Technical Service Bulletin: TSB120052

New Low Pressure Fuel Lines for the QSK38 MCRS, QSK50 MCRS, and QSK60 MCRS Engines

Old Fuel Line

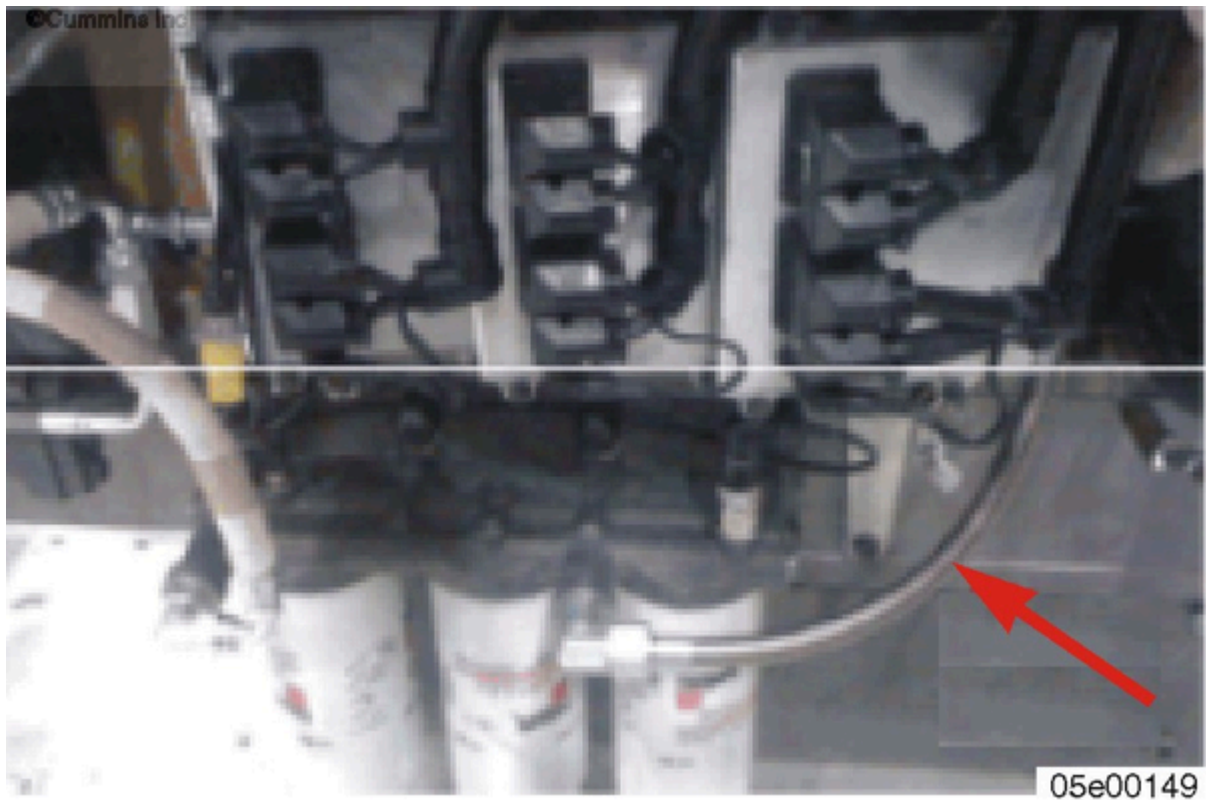
This document introduces new low pressure fuel lines for the QSK38 MCRS, QSK50 MCRS, and QSK60 MCRS engines with electronically actuated injectors. The new lines are more robust against electrostatic discharge, which has caused a pin hole in the braided section of the old lines, leading to a fuel drip. Cummins Inc. recommends replacing all of the lines, if any old low pressure fuel lines listed in the tables below, are leaking from the braided section.

New Fuel Line

Old Installation

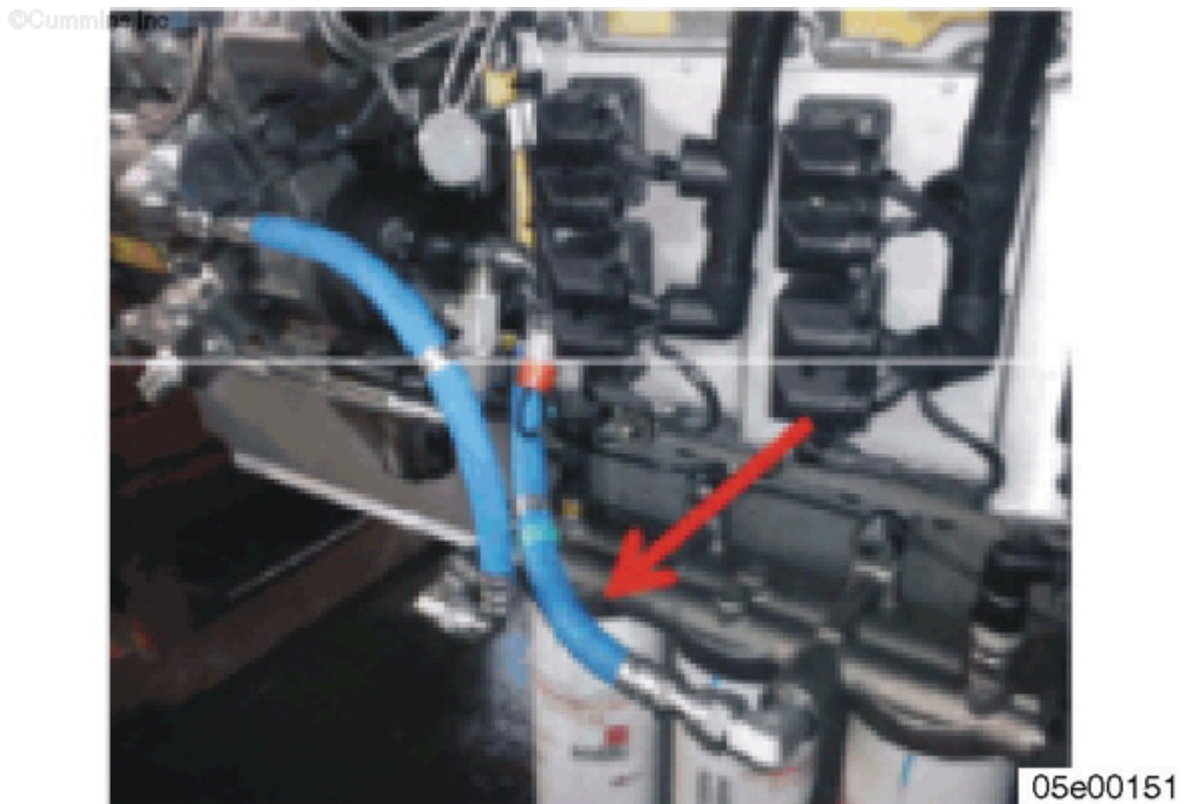
Along with the material change on the QSK50 Gerotor Outlet to Stage 2 Filter Head line was a routing change. Previously this fuel supply line was routed behind the ECMs. The new part number fuel supply line is now shorter and routed in front of the ECMs. See the pictures below.

New Installation
